Examining the drive aisle and possible hazards on 35 ft. or 28 ft. residential streets being considered for the proposed Hillview Crossing - and the 21 ft. access road that links residences to the main road (varied parking / vehicles that frequent neighborhoods)

By Teresa Jacobs October 2019

28 ft wide road - IDEALLY, parking only on one side. But "no parking" is not easily and consistently enforceable for an HOA / Drive aisle is unpredictable.

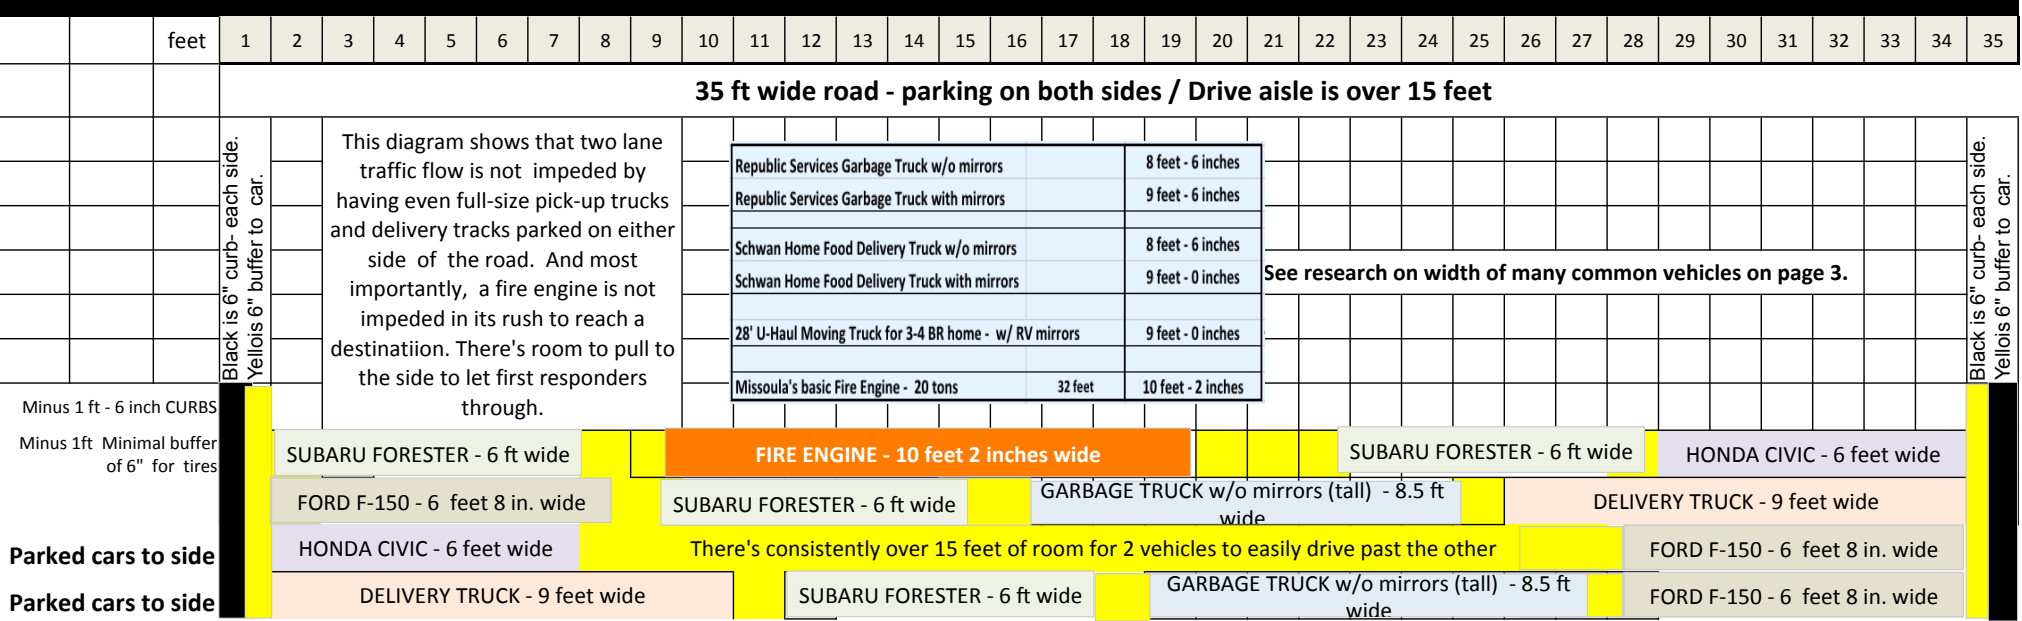
This diagram shows that with 28 foot roads, if no parking on one side is enforced, there can be two lanes of traffic flowing. Parking violations will force the inconvenience of one lane of traffic, while dodging oncoming traffic doing jogs off to side to let other cars pass. BUT NOTE that an illegally-parked delivery truck or U-Haul truck can block a fire engine from passing.
